SUBJECT: Consideration of tentative approval of the request of Pulte Homes of Michigan, LLC, for Emerson Park, JSP 17-10, with Zoning Map Amendment 18.717, to rezone property in Section 22, located on the west side of Novi Road between Ten Mile Road and Grand River Avenue from OS-1, (Office Service) to RM-2 (High Density Multiple Family Residential) subject to a Planned Rezoning Overlay (PRO) Agreement, and corresponding PRO Concept Plan. The property totals approximately 24 acres and the applicant is proposing a 120-unit multiple-family attached condominium development.

SUBMITTING DEPARTMENT: Community Development Department – Planning

RE: Emerson Park - Conceptual PRO
Public Benefit Consideration - Modification

sheet title:
OVERALL PLANTING PLAN VIEW

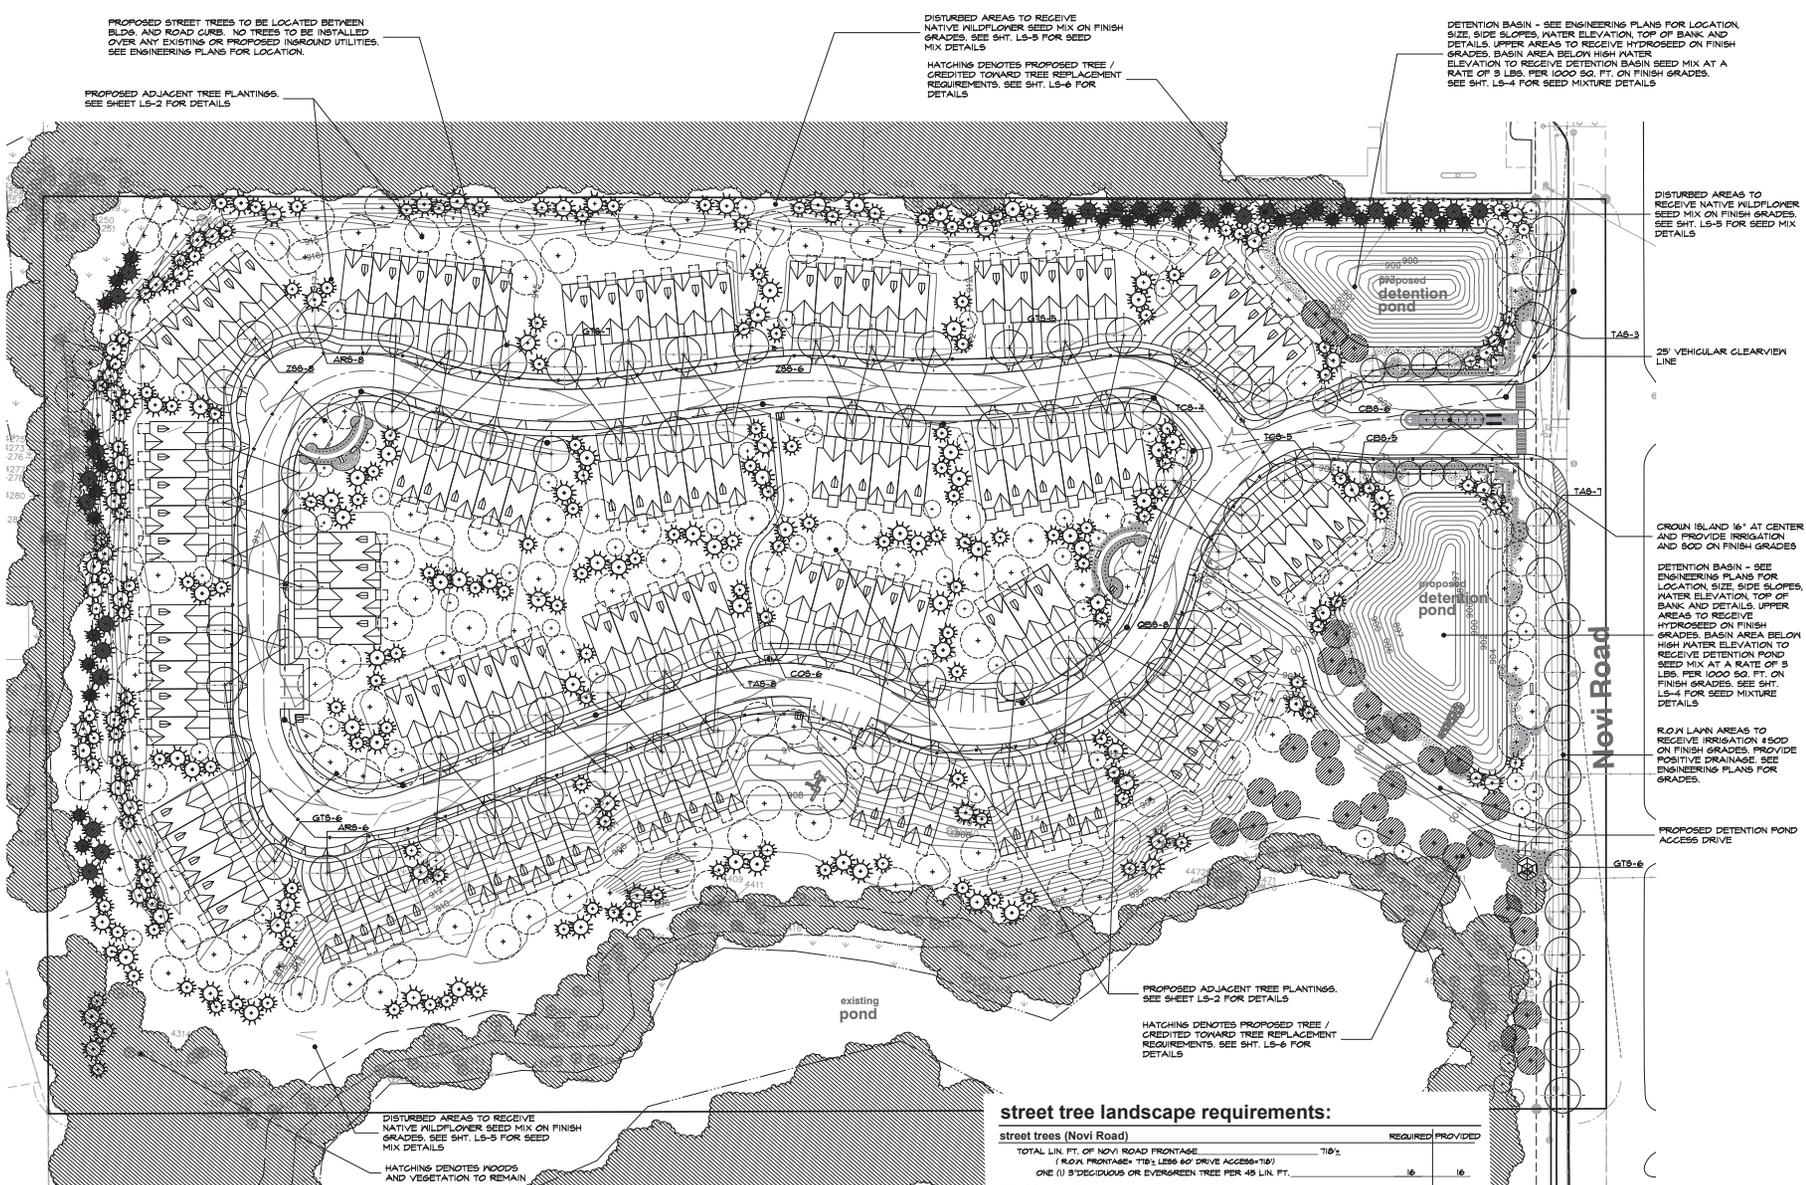
4. There is a contradiction between the two figures used as a basis for the street trees calculations. 3349 lf is shown as the basis, but the calculations show the number to be 2821 lf. The latter figure was used for the tree requirement. **Please use the correct number as the basis and remove the incorrect figure from the calculations. If the correct figure is 2,080 lf, then more than the required number of street trees is provided.**

1. The detail is provided on Sheet 4.
2. **When proposed transformers/utilities/fire hydrants are available, add them to the landscape plan and adjust plant spacing accordingly.**

Figure 1. City of Novi Regulated Wetland & Woodland Map (approximate project area is highlighted in red). Regulated Woodland areas are shown in green and regulated Wetland areas are shown in blue).

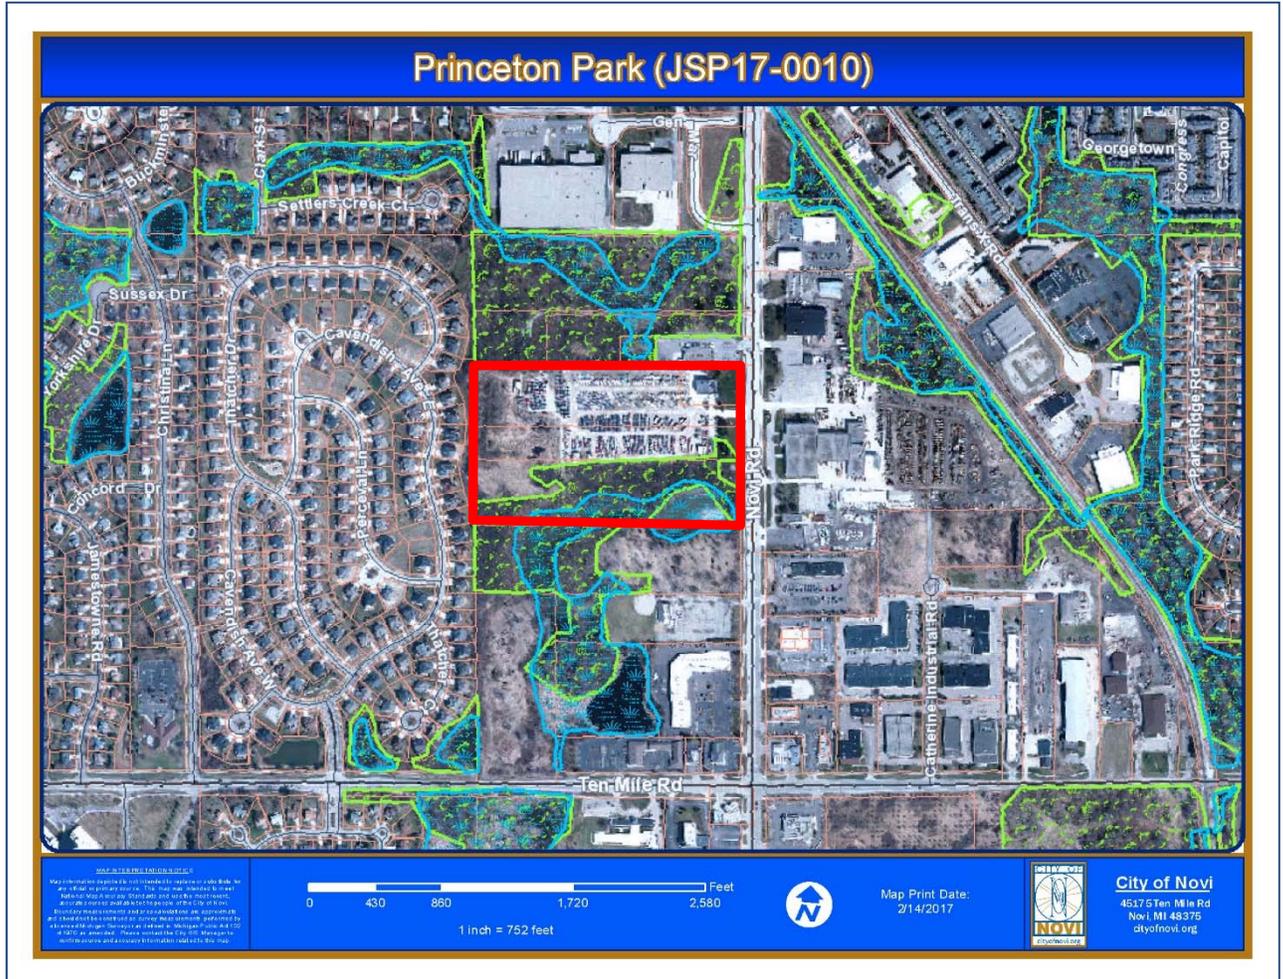
Based on our review of the Plan, Novi aerial photos, Novi GIS, the City of Novi Official Wetlands and Woodlands Maps (see Figure 1, attached) it appears as if this proposed project site contains City-regulated wetlands and woodlands. The City's wetland and woodland map shows that the overall property contains wetlands to the south. However, a review of aerial photos of the site and the proposed site plan, the site contains three (3) areas of wetland (Wetlands #1, #2, and #3), along both the southern and western portion of the site.

As noted, three (3) areas of wetland exist on this parcel (Wetland #1, #2, and #3). The proposed site development appears to be partly designed around the existing on-site wetland and 25-foot wetland setback areas. The *Layout Plan* (Sheet 05) indicates that the proposed development will impact Wetland #3 and the storm water outlet is currently planned to be directed to the 25-foot setback of Wetland #1, in the southeast portion of the site. The following table summarizes the existing wetlands and the proposed wetland impacts as shown on the Plan:

Figure 1. City of Novi Regulated Wetland & Woodland Map (approximate project area is highlighted in red). Regulated Woodland areas are shown in green and regulated Wetland areas are shown in blue).

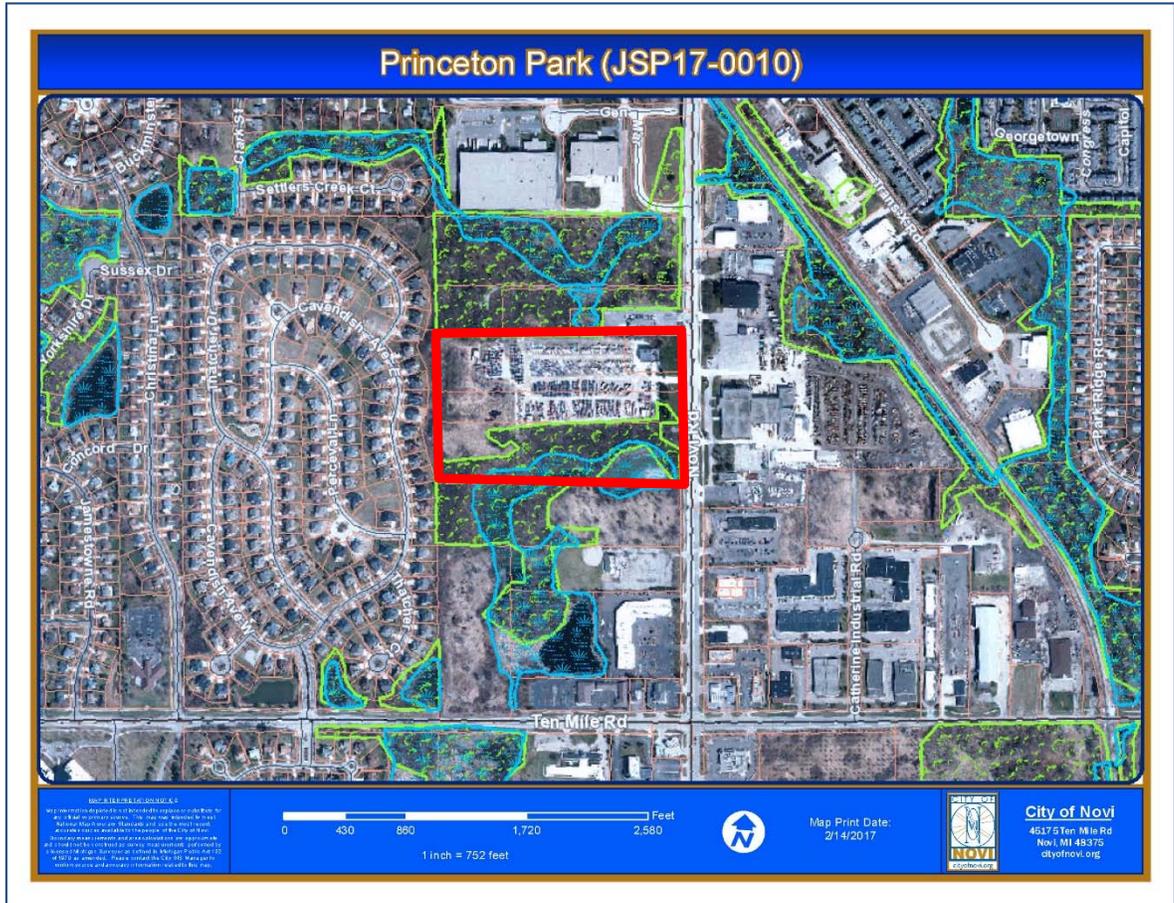
ECT completed an on-site woodland evaluation on Tuesday, February 21, 2017. As noted above, the site does contain area designated as City of Novi Regulated Woodland. A significant portion of the proposed limits of disturbance for the project is located outside of the areas mapped as City Regulated woodland (see Figure 1). The

majority of the Regulated Woodland area is located on the southern portion of the project site (see Figure 1). Tree survey information has been provided on the *Tree List* plan (Sheet 03). This sheet includes a tree list that indicates the proposed woodland impacts and required Woodland Replacement tree credits for these removals. The Plan indicates that a total of 328 trees have been surveyed for the project. Of the trees surveyed, 262 trees are located within the area designated as Regulated Woodland (80% of the surveyed trees are located within the regulated woodland area). Fifty percent (50%) of the surveyed trees are comprised of the following tree species:
